Service Bulletin

Bulletin No.: 18-NA-056

Subject: Drivers Side Object Sensing Alert Module Not Working Correctly and/or Incorrect Side Mirror Notification

Brand:	Model:	Model Year:		VIN:		Engine:	Transmission:
		from	to	from	to		
Buick	Encore	2017	2019

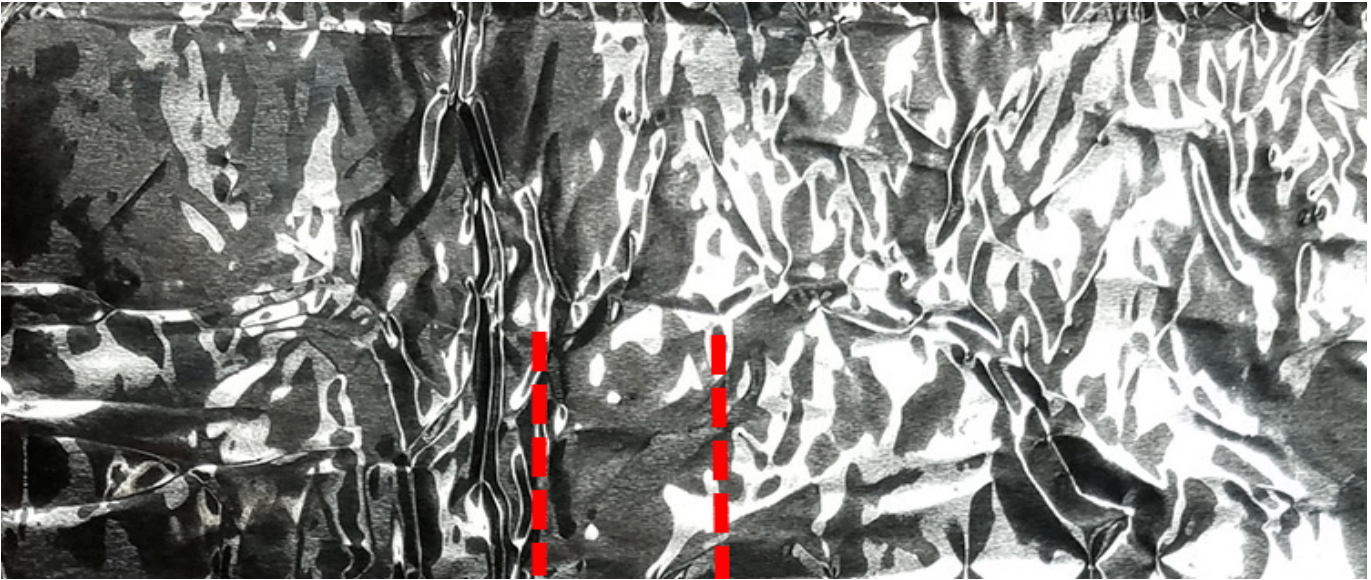
2. Remove the drivers side rear wheelhouse liner (3). Refer to *Rear Wheelhouse Liner Replacement* in SI.
3. Separate the wiring harness from the anchor point under the module.

Note: The lower area must be completely covered including the wire harness anchor point to avoid unwanted radar reflections to be detected.

4. Using Acrysol or equivalent, clean the bottom of the module and fascia.
5. Using care, cut a 3½ inch wide section of butyl tape.

6. Using care, cut a relief for the reflector mount in the middle of the tape.
7. Pre-install the butyl tape and check for alignment to the reflector mount.

8. Align the pre-cut relief with the reflector mount (2).
9. Peel the backing off the aluminum butyl tape and apply to the bottom of the module (1) and fascia making sure the area is completely covered as shown in the graphic above.
10. Install the wiring harness into the anchor point (3).
11. Install the drivers side wheel house liner.
12. Lower the vehicle.
 - If the side blind zone and/or side mirror indicators are performing properly, no further action is required.
